# **ADDENDUM NO. 2**

## **RIVERWALK WEST FINAL PHASE**

**BID #26-012**

**ISSUED: May 14, 2026**

SHEET NO. 04 OF 20  
 PROJECT NO. 15842.00001  
 DATE: APRIL 15, 2026  
 SCALE: 1"=50'  
 DRAWN BY: JRH  
 CHECKED BY: DLO  
 DESIGNED BY: JRH

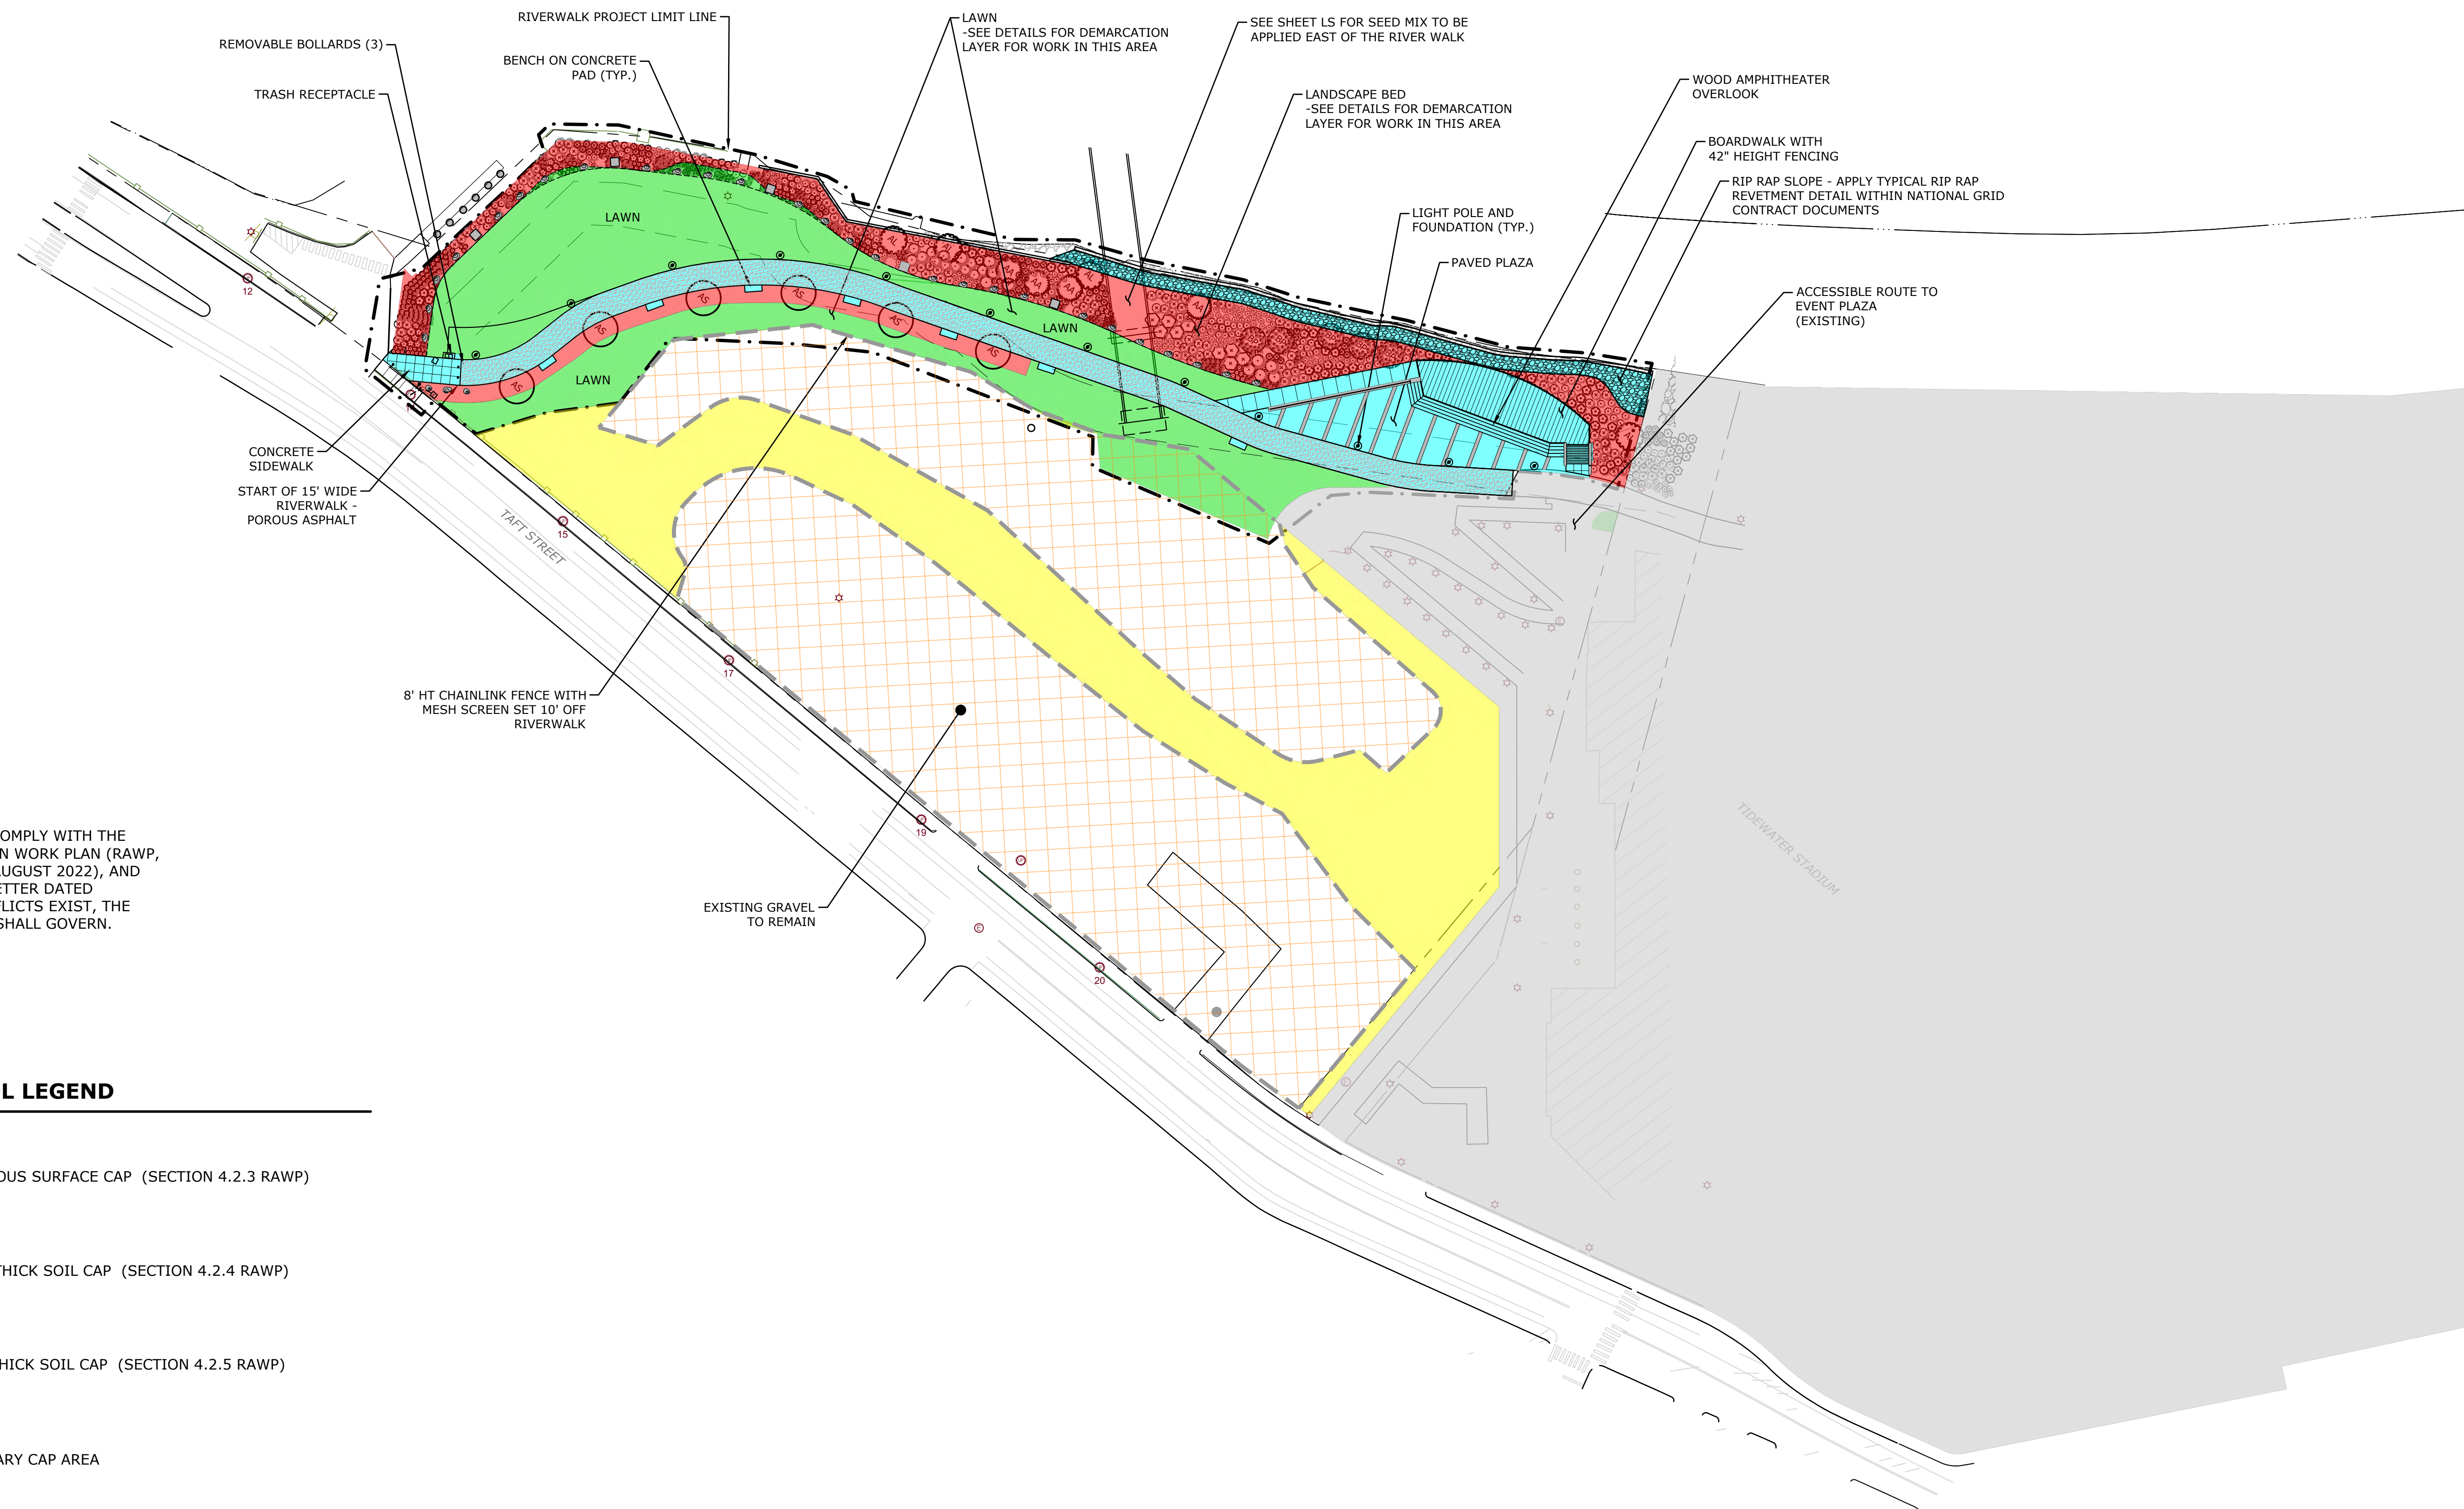
- Q5:** Sheet EC - The drawing shows the 1' cap outside the limits of the work line. Please clarify that this is correct.
- A5:** Response: C.L.L. limit was corrected to correspond with earthwork. Work within the C.L.L. line will be capped per the legend.

**GU**

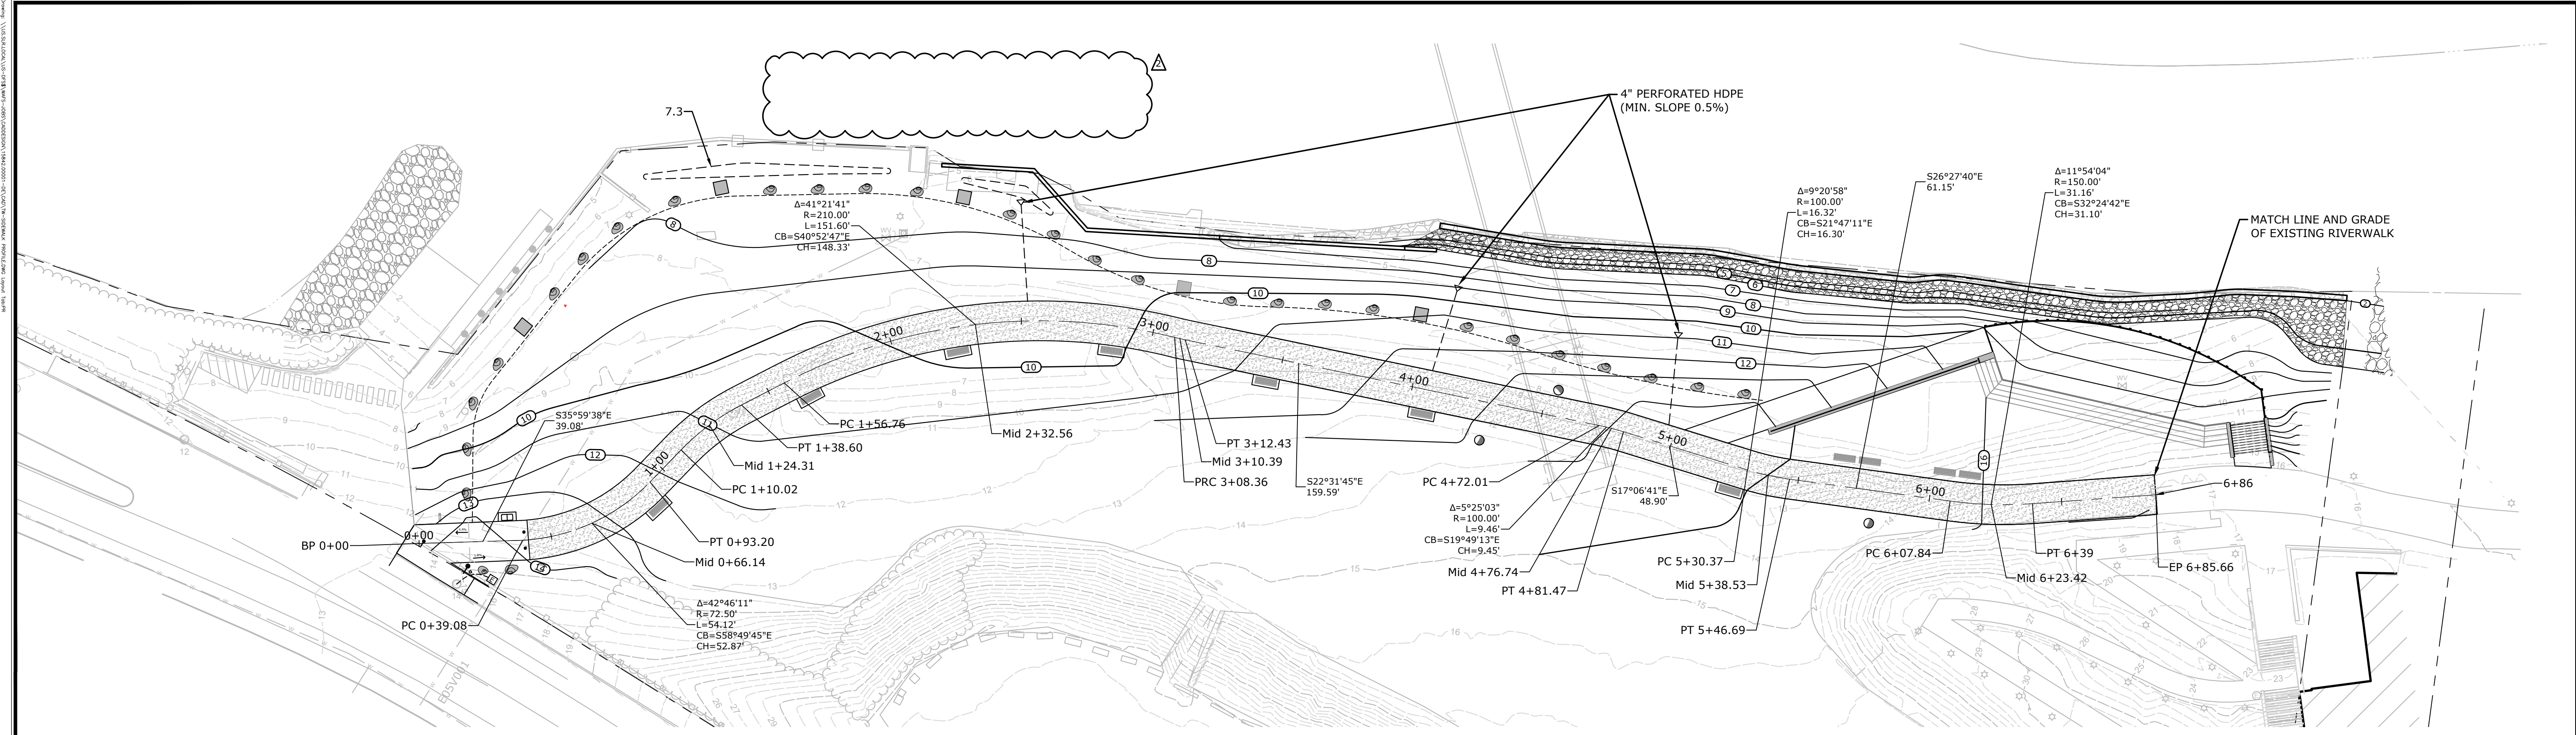
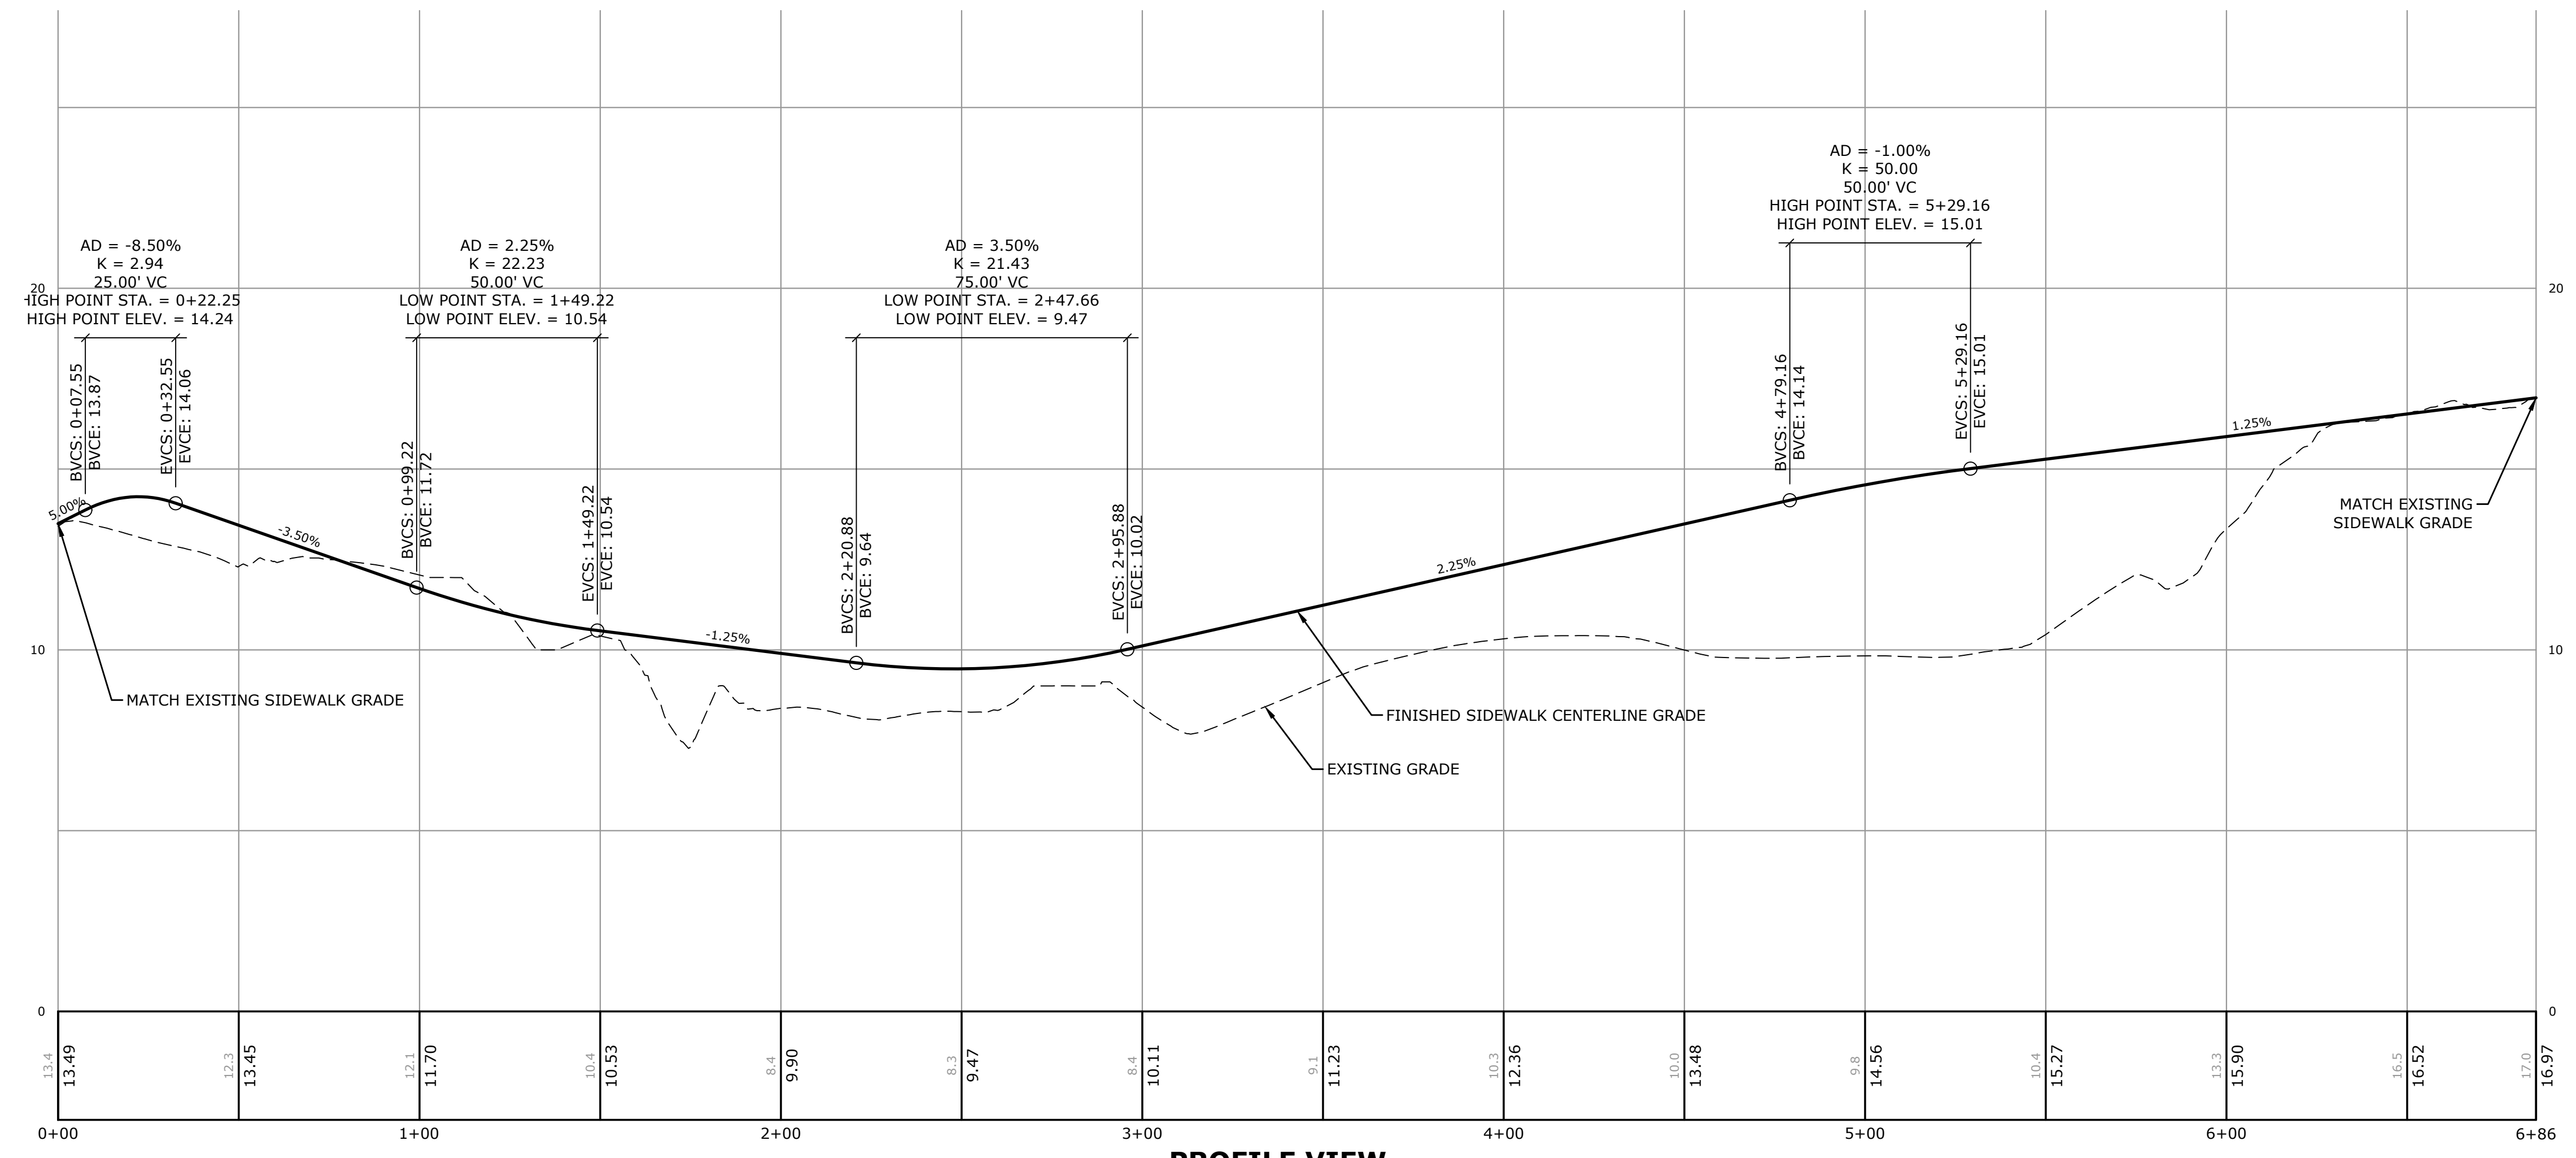
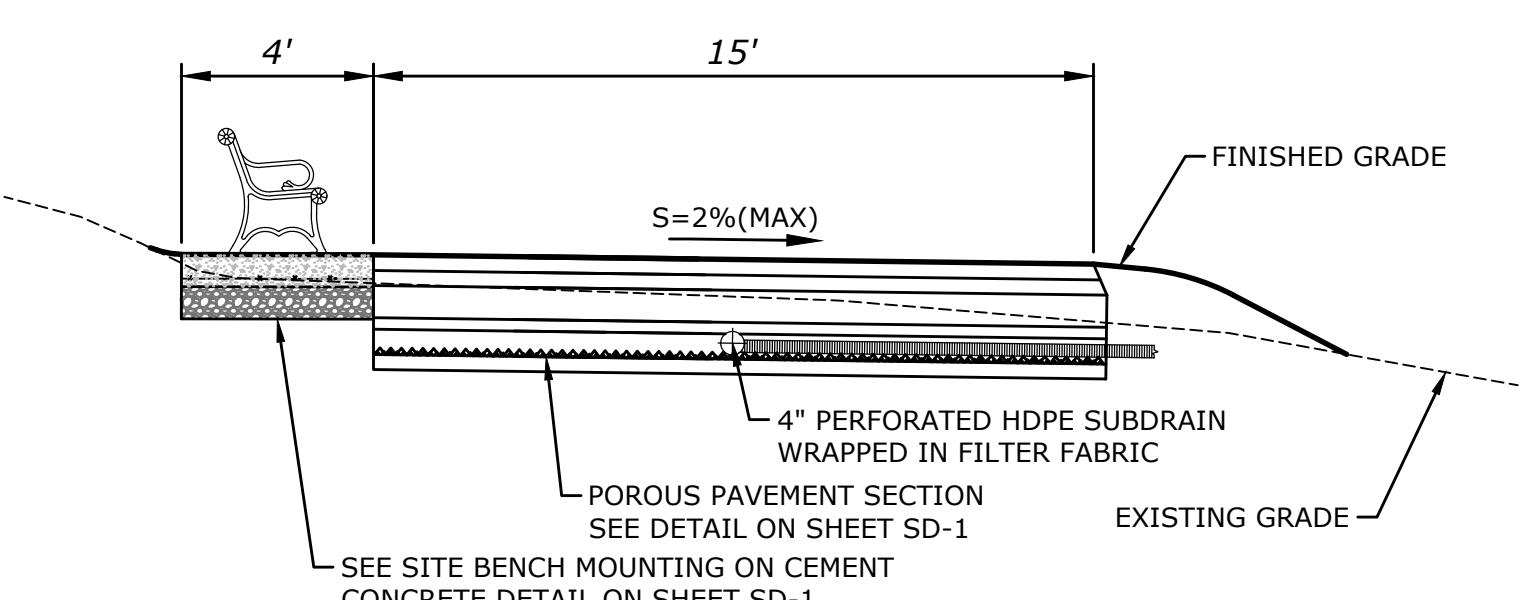
- Q11:** Sheet GU - Please clarify the size of the Area Drainage and Manholes.
- **Also clarify if the 12" HDPE is being connected to an existing Drainage MH.**

- A11:** Response: Information has been added to the sheet GU and details (SD-5). The proposed drainage will connect to a stub installed under the existing walk. Pipe is 18" HDPE.
